ADDENDUM NO. 02

Project: Wastewater Treatment Facility
Headworks Improvements
Paragould Light, Water, & Cable
Paragould, Arkansas

YARD PIPING PLAN C-4

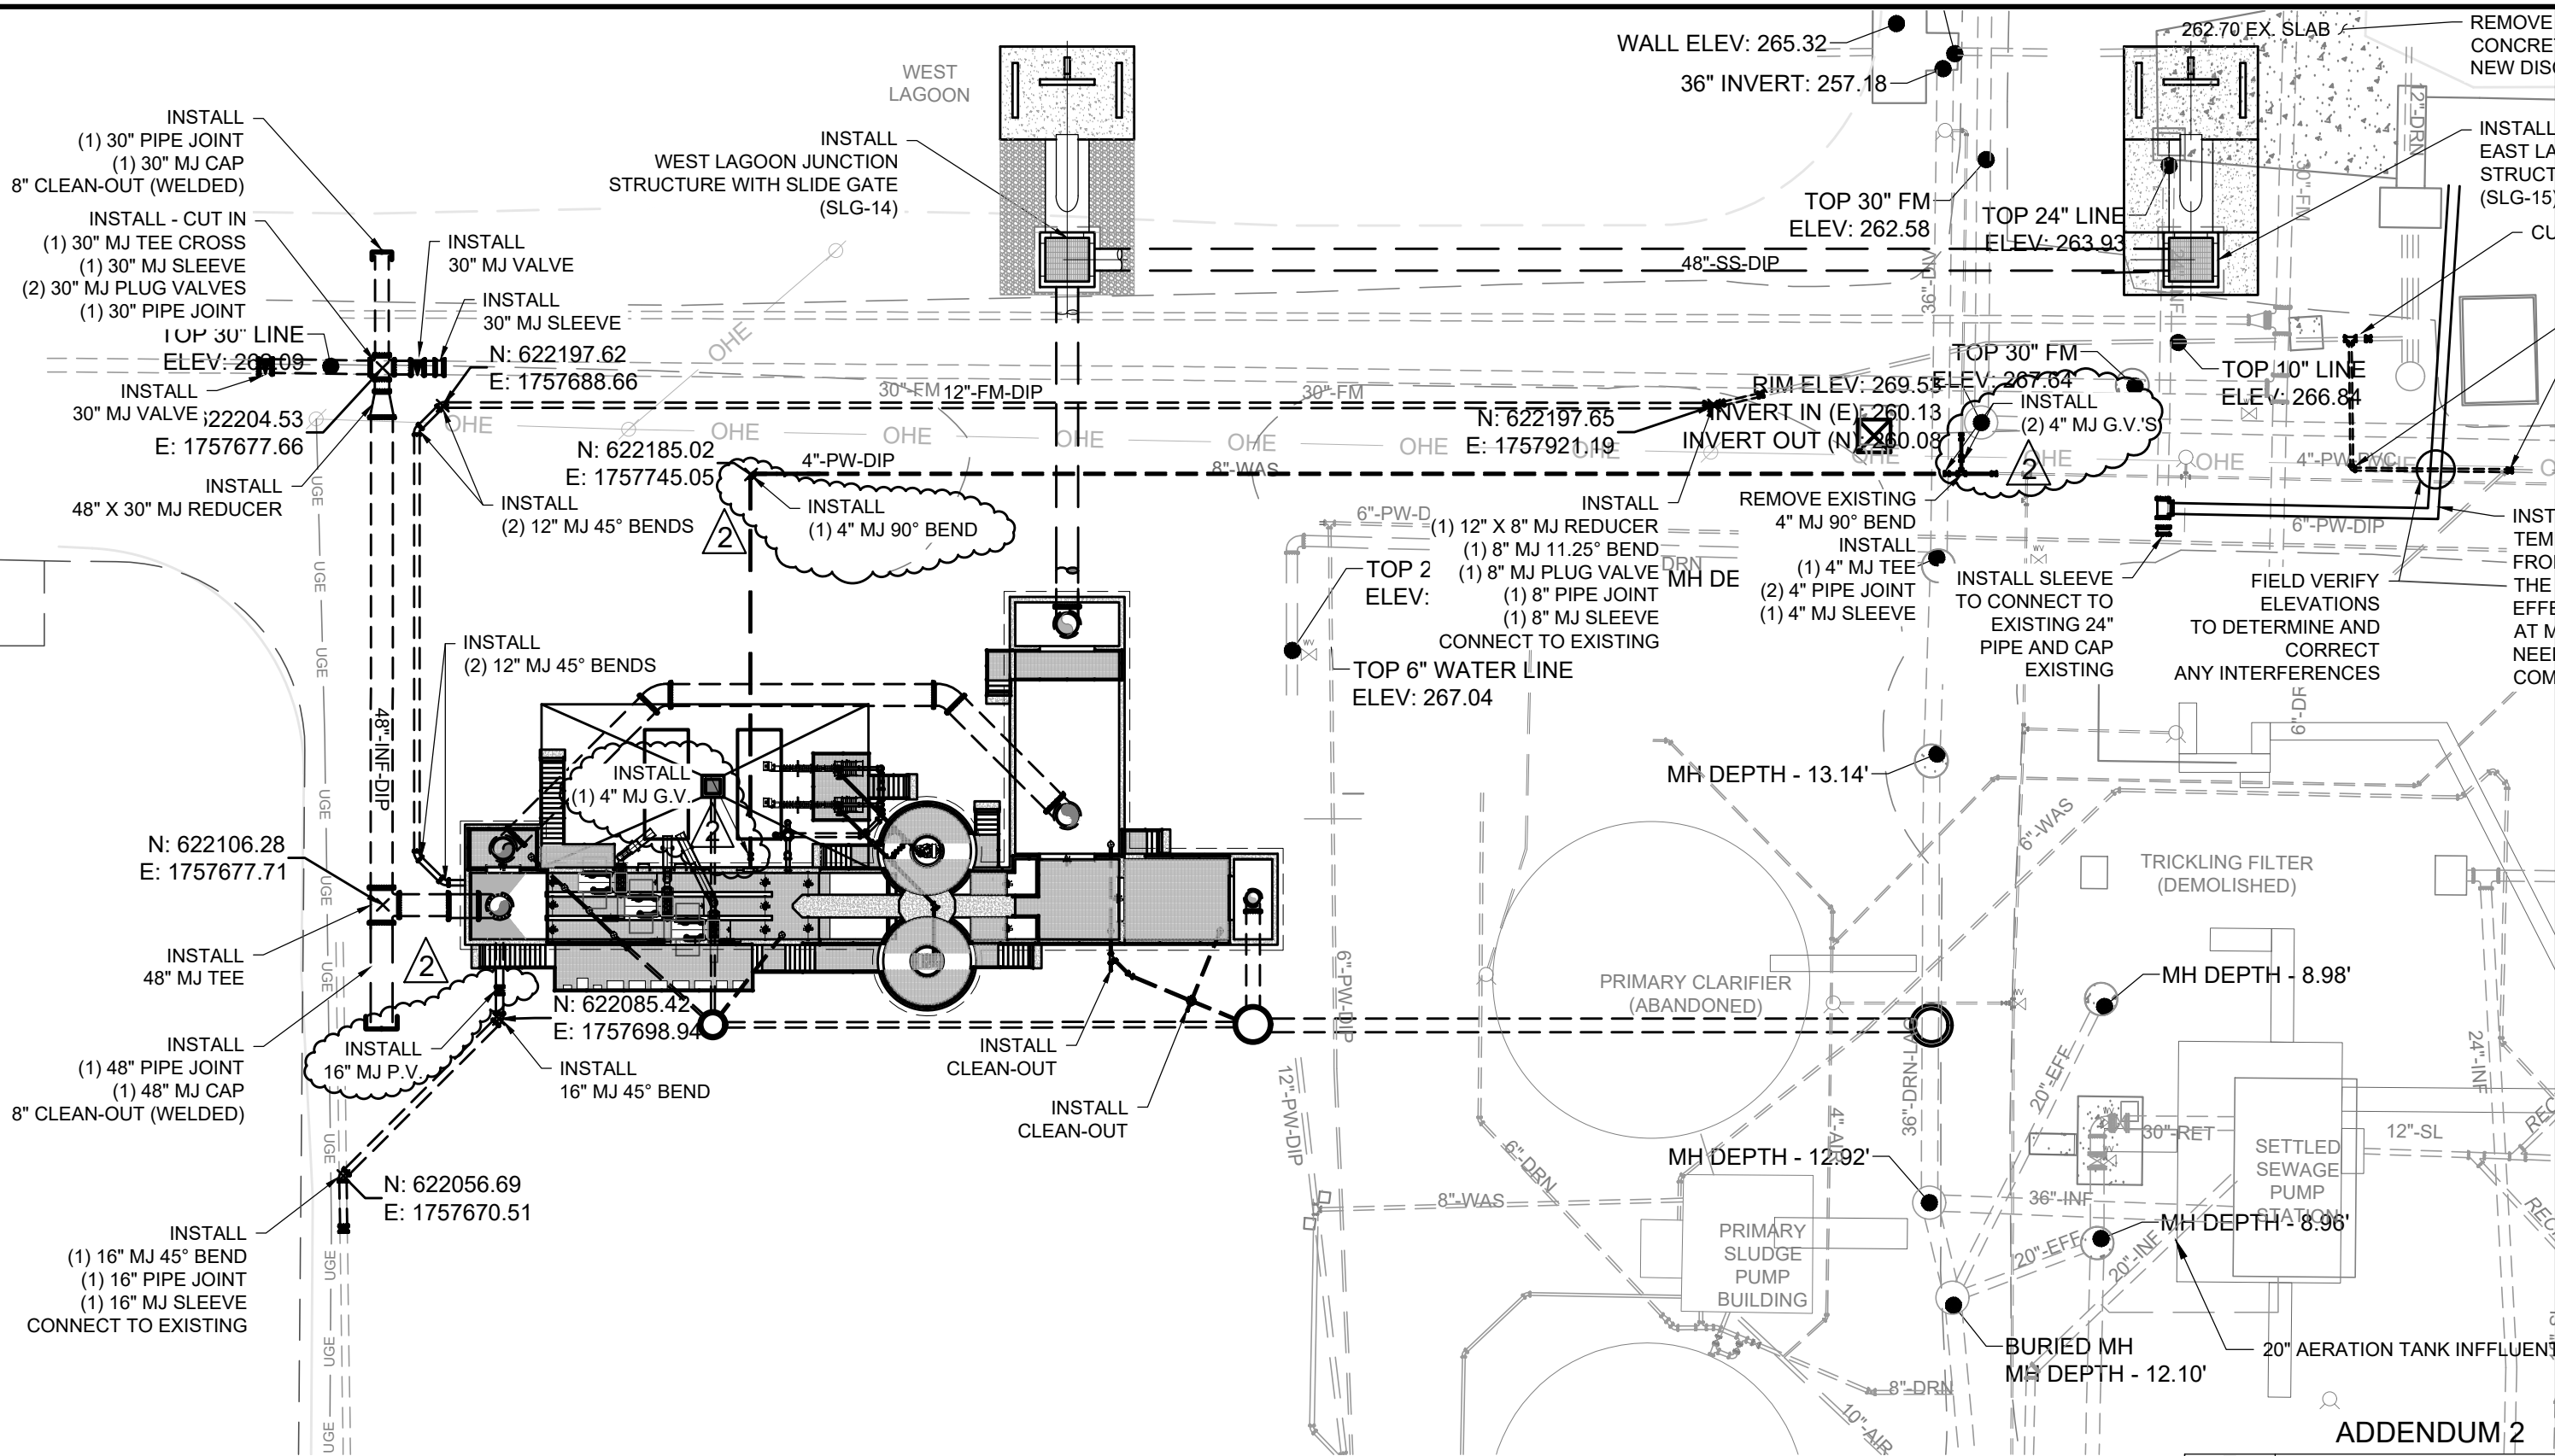
1. Drawing C-4 – Yard Piping Plan:
 - a. Modify this drawing as shown on the Addendum No. 2 – Yard Piping Plan, attached hereto.
1. Drawing S-2 – Foundation Plan:
 - a. Modify this drawing as shown on the Addendum No. 2 – Foundation Plan, attached hereto.
